"NRC Technical Assistance
for Design Reviews"
Contract No. NRC-02-85-002
FIN D1016

Enclosed are the following Itasca Document Reviews, prepared under NRC Contract NRC-02-85-002, Task Order No. 006, Task 1.

ITASCA DOCUMENT REVIEW

Document Title: "Exploratory Shaft Facility Water Inflow Design Calculations" by R. I. Watkins (RHO Computational Brief CB-00617, February, 1987)

Fig. 2 Diagram Illustrating Waste Package Terminology

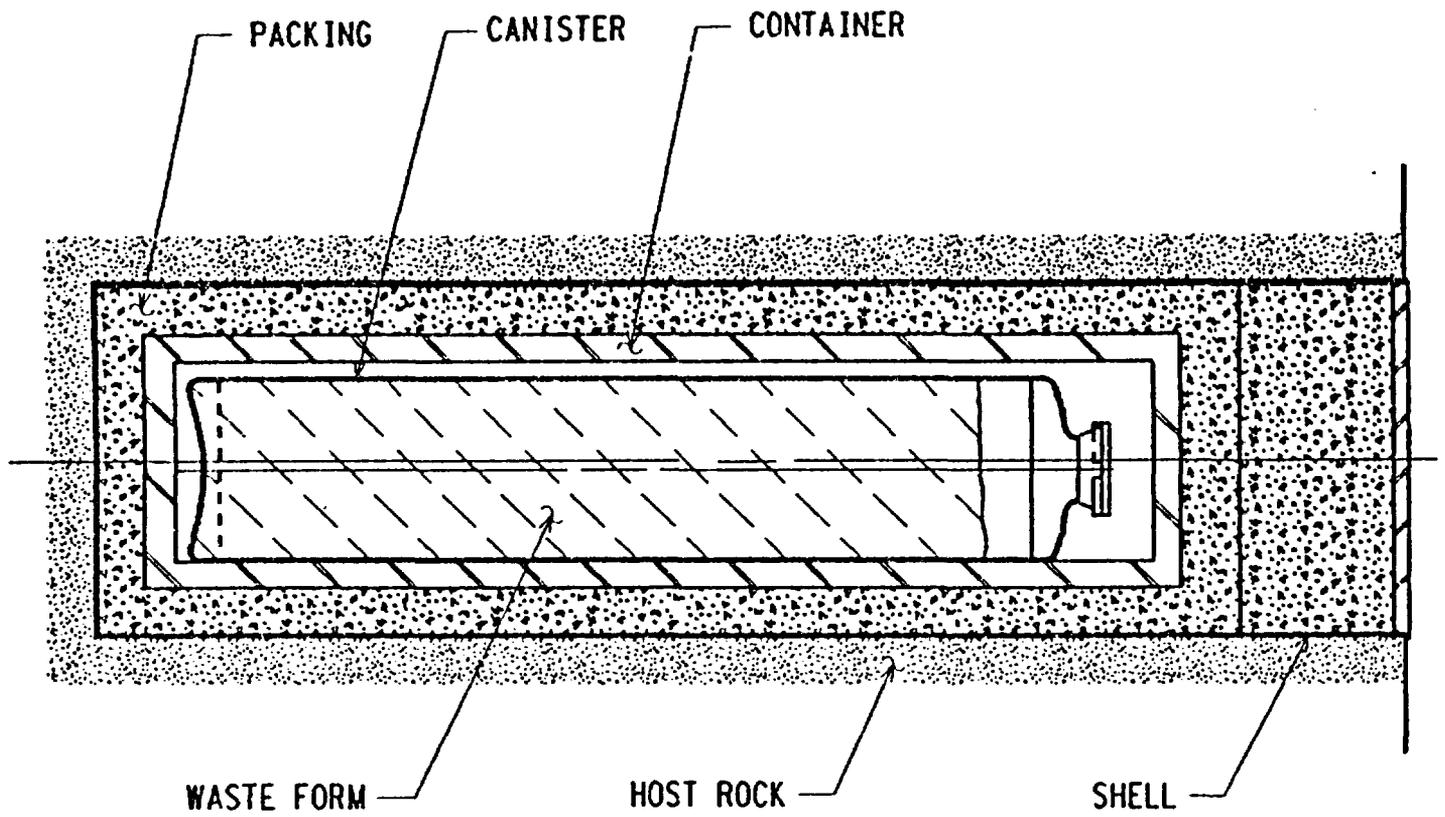
In addition to the higher temperatures predicted for the Alternate Design WP, other problems can be expected that have not been recognized. Drilling a borehole that is over 2.5 m in diameter and 6 m long can cause practical problems with respect to equipment, size of the disturbed zone, height of the emplacement drift, and proximity to the next hole (i.e., WP pitch). It may be difficult to maintain a stable hole that large in the high stress environment at BWIP.
